30 Monument Street Single Family Residence  
Project Summary

## Jeanie Bourke - Re: 30 Monument St. Bp#2014-02773

Address/Location of Construction: 30 Monument Street		
Total Square Footage of Proposed Structure:		same
Tax Assessor's Chart, Block & Lot Chart#      Block#      Lot# 16-E-10	Applicant Name: Brewster Buttfield Address 58 Fore Street City, State & Zip: Portland, ME 04101	Telephone: 207-749-7400 Email: brewster@prospectdesign
Lessee/Owner Name: Rich Robinov (if different than applicant) Address:  City, State & Zip: Portland, ME Telephone 207-747-9084 E-mail:	Contractor Name: Cornerstone Build (if different from Applicant) Address: 100 Congress St. City, State & Zip: Portland, ME 04101 Telephone 207-939-0185 E-mail:	Cost Of Work: \$ C of O Fee: \$ Historic Rev \$ Total Fees : \$ 69.00
Current use (i.e. single family) <small>single family</small> If vacant, what was the previous use? Proposed Specific use: <small>single family</small> Is property part of a subdivision? ___ If yes, please name _____ Project description: This is an addendum to permit number BP# 2014-02773. Addition of finished basement, emergency egress well and details on one hour wall.

REVISION  
DRAWN BY: RB  
DATE: MARCH 5, 2015

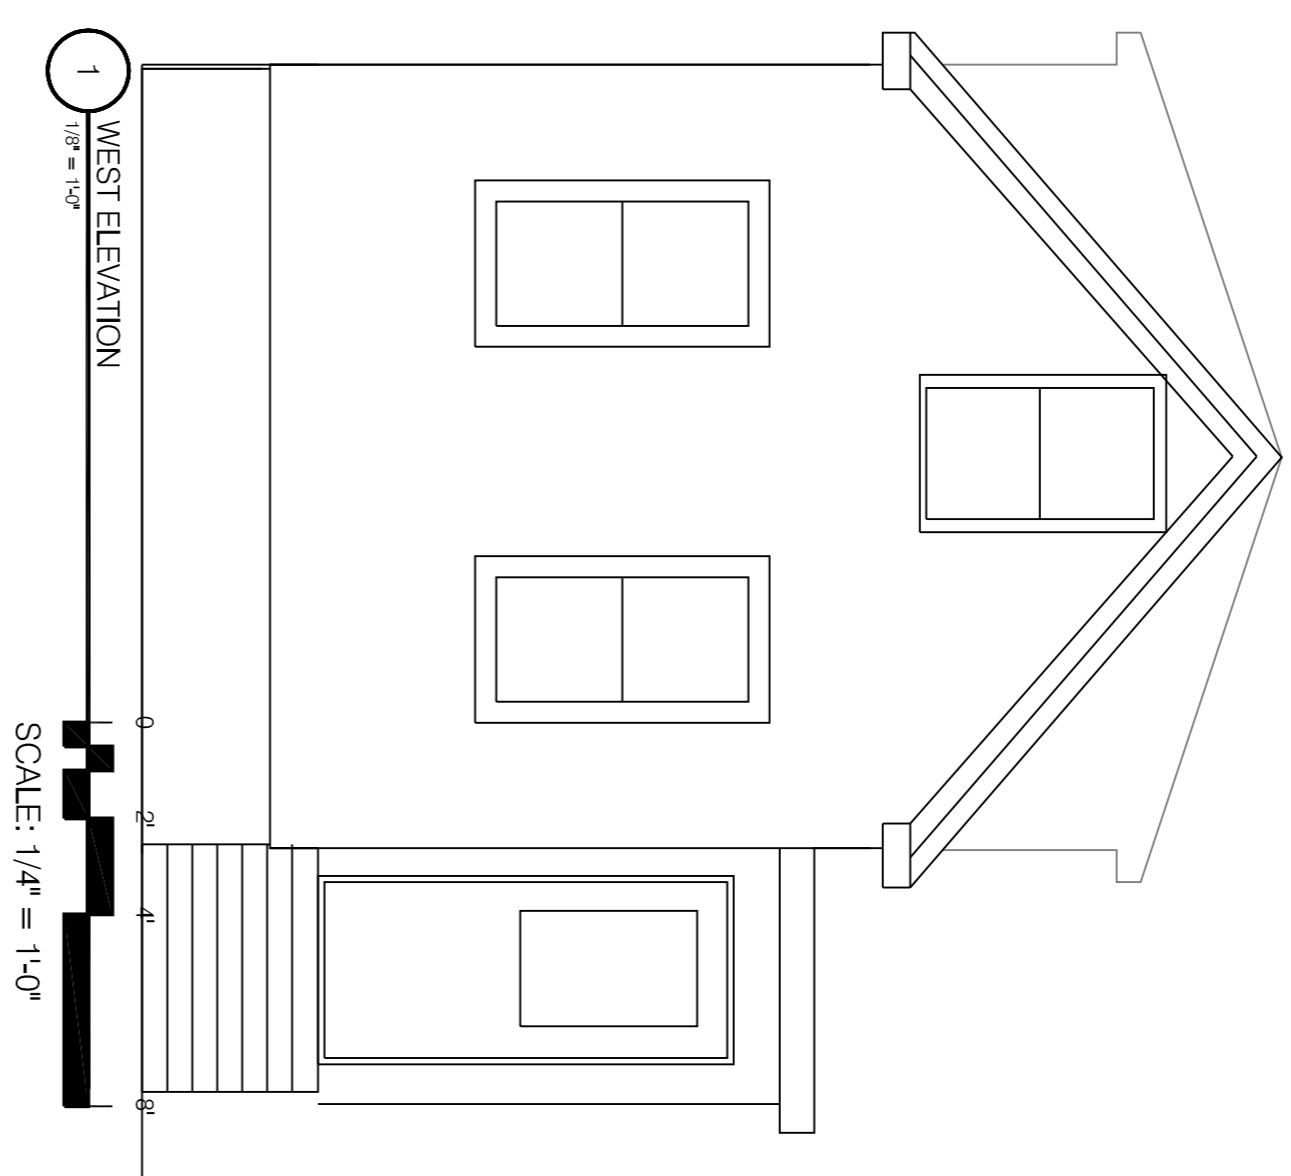
3. An updated plan for the deeper basement is a new sheet, A-103. It shows the required egress well, the stairs to basement instead of a hatch and the required thermal barrier for the insulation. **This, as well as any other changes need to be updated on all associated plans, ie. sections, etc.**

3. Based on the field inspection by George for the footings, it was confirmed with the contractor that the house will have a full basement. If this is correct, an amendment is required for this change and should include the access and emergency escape and rescue opening.

A-200

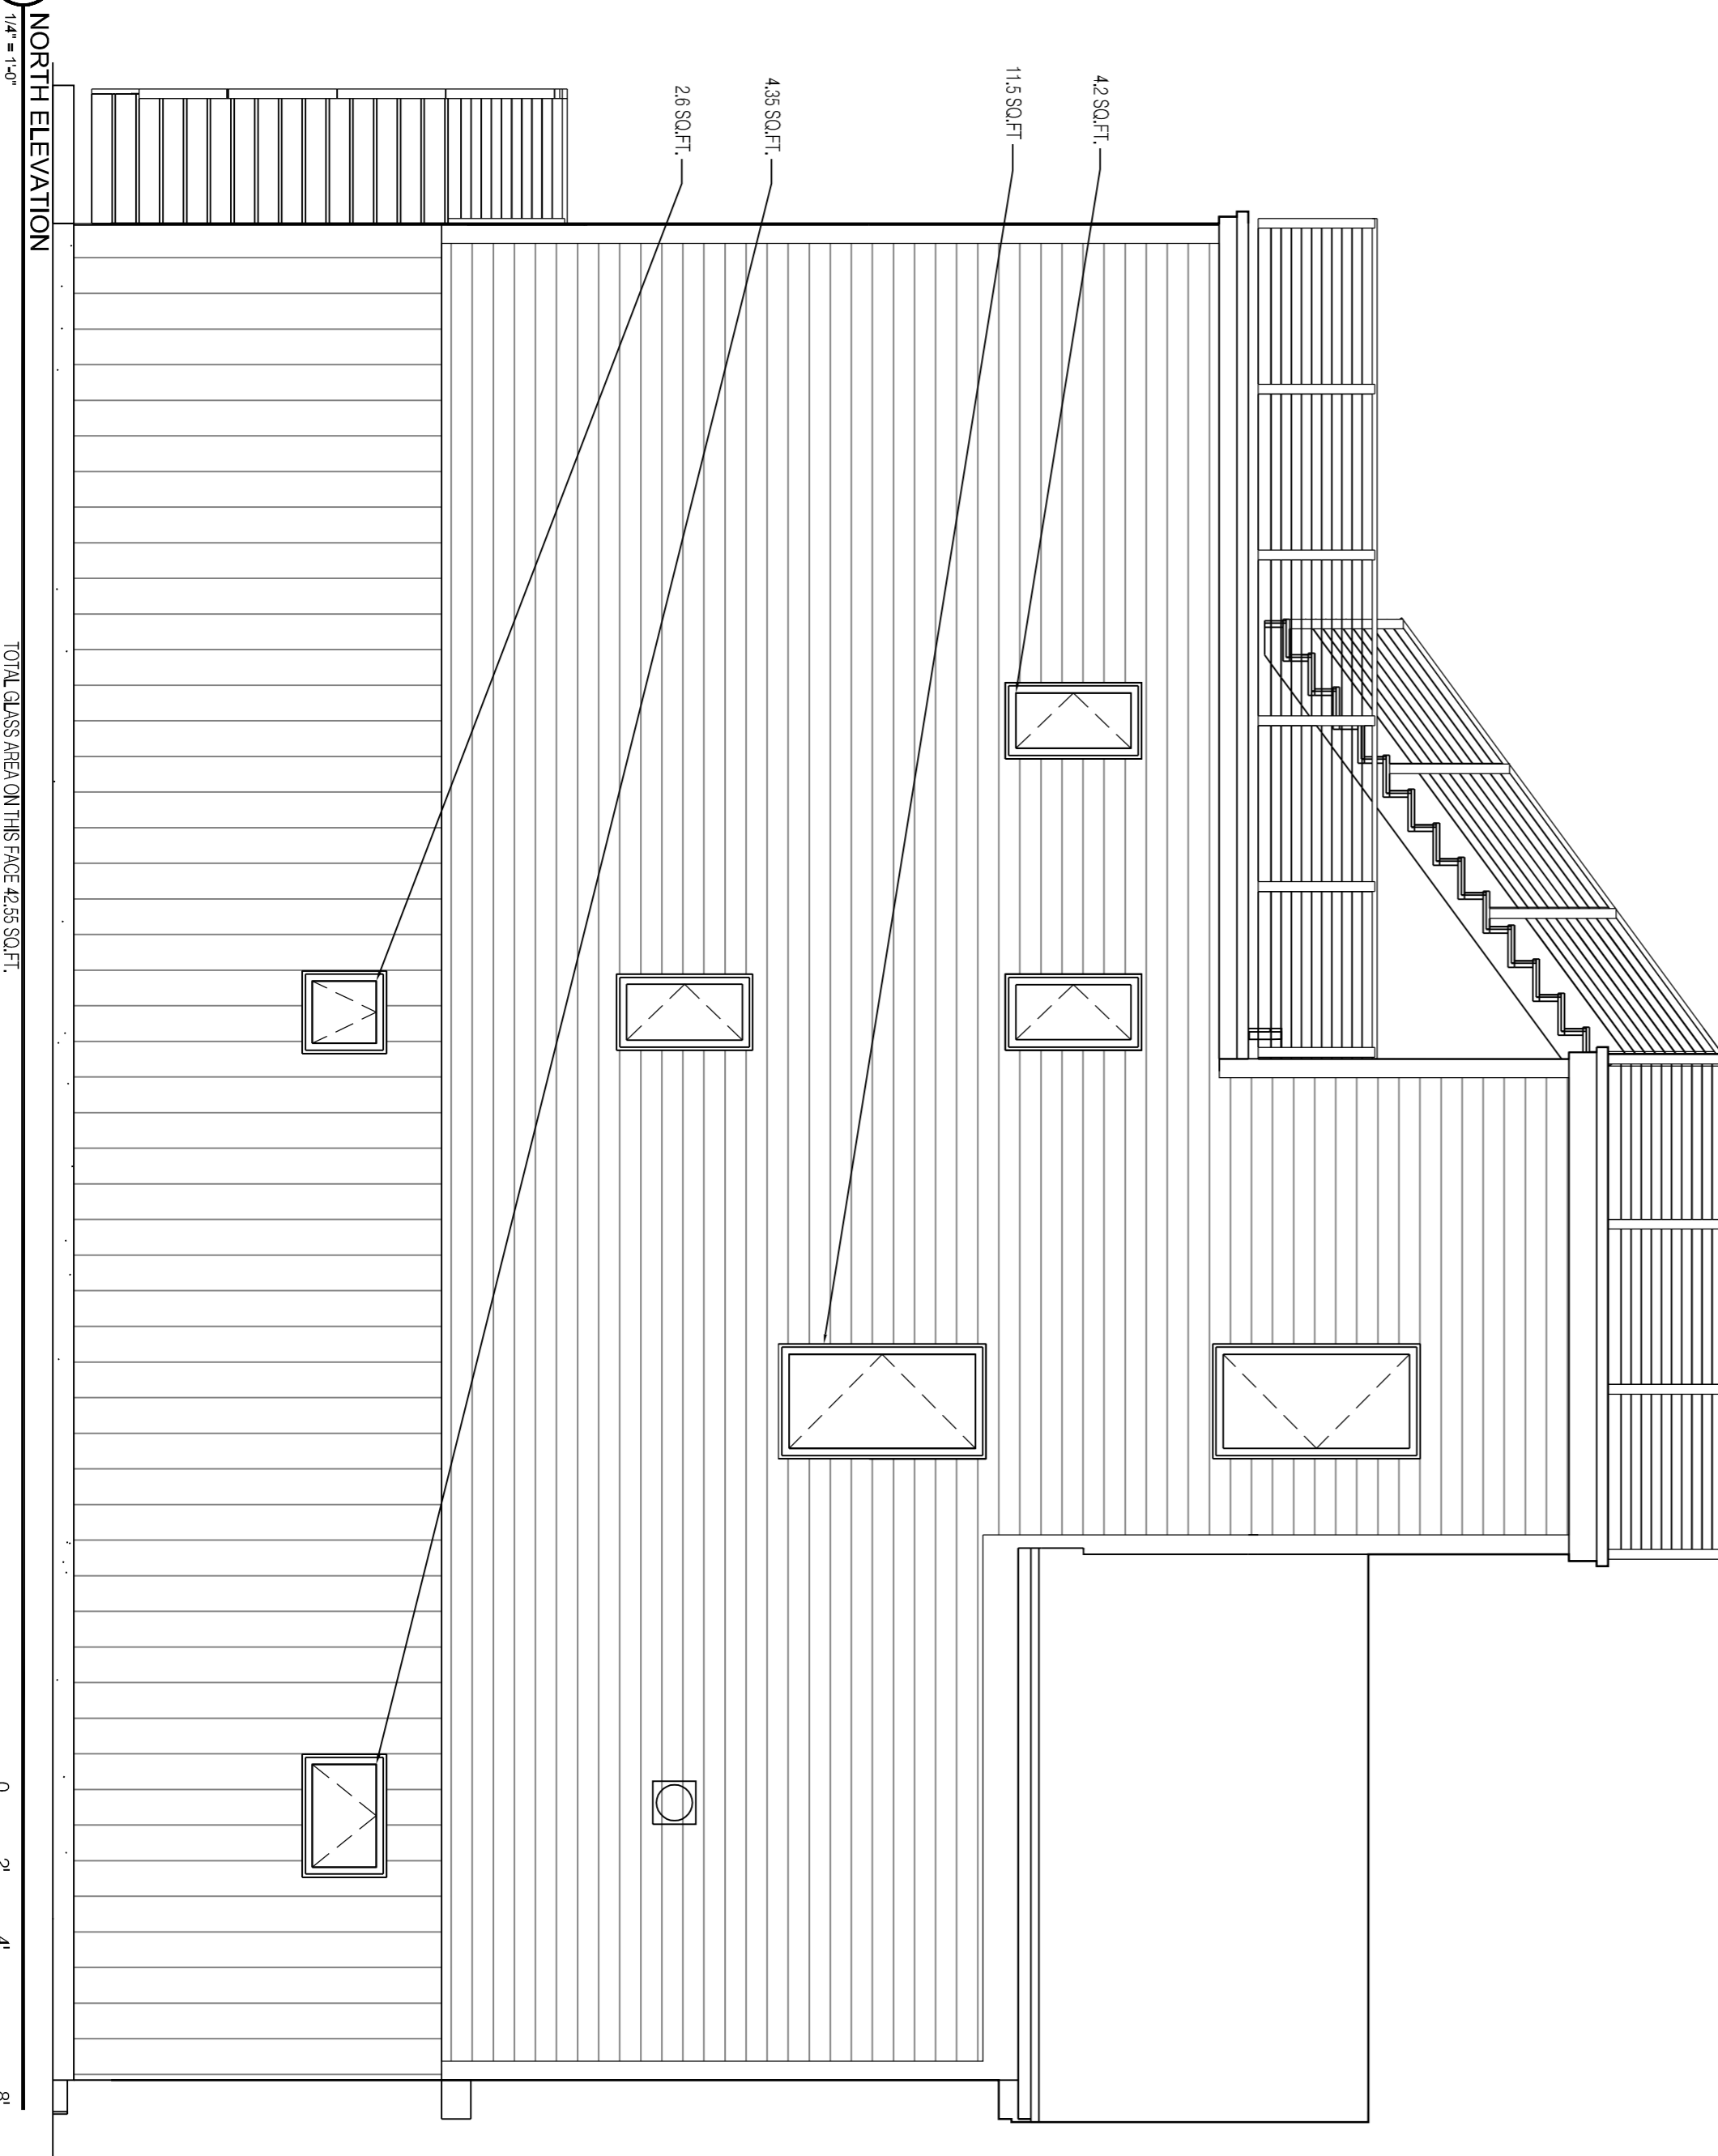
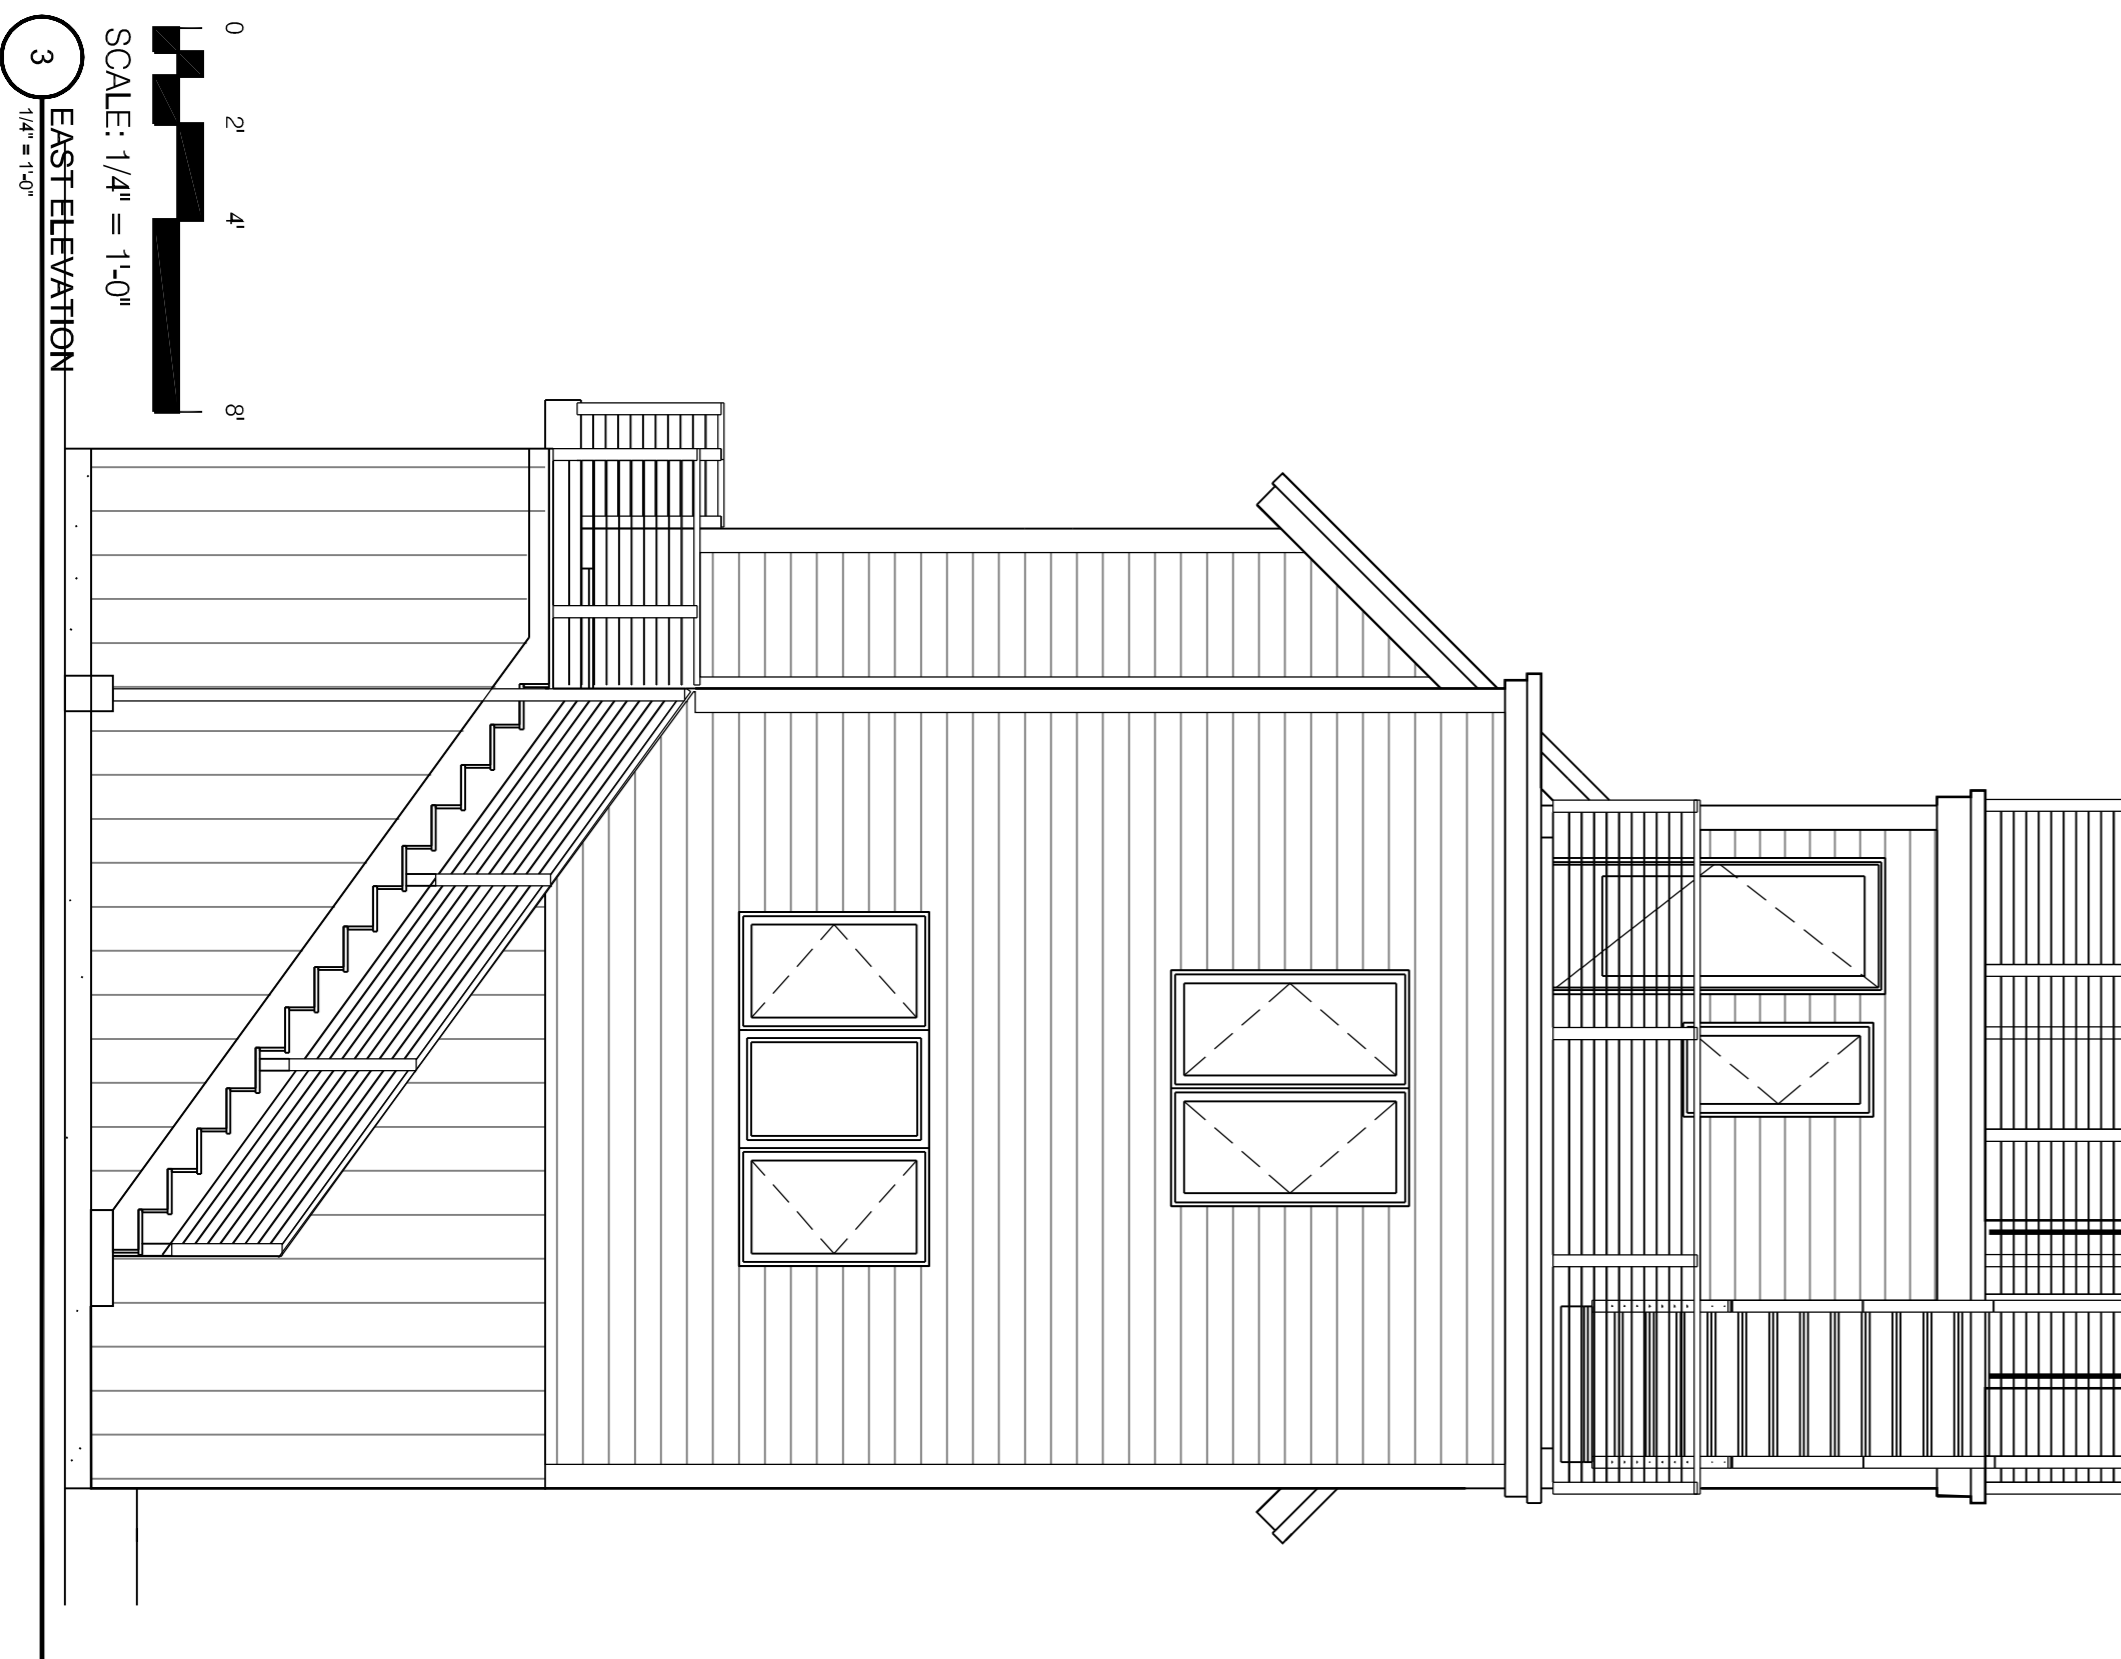
2. The window quantity is actually the same if you can the original basement windows (see photo below). The actual area of glass is reduced in the proposed plan by 17 sq.ft. This is shown on the existing and proposed elevation drawings. **This is acceptable.**

1. Provide a 1 hour exterior wall detail, rated from both sides per Table 302.1 and UL 263 for the northeast wall.
2. Provide the percentage of glazing & openings of the existing and proposed northeast wall. With this

February 4, 2015  
March 5, 2015 SHOW GLASS AREA ON THIS FACE  
BB  
March 5, 2015
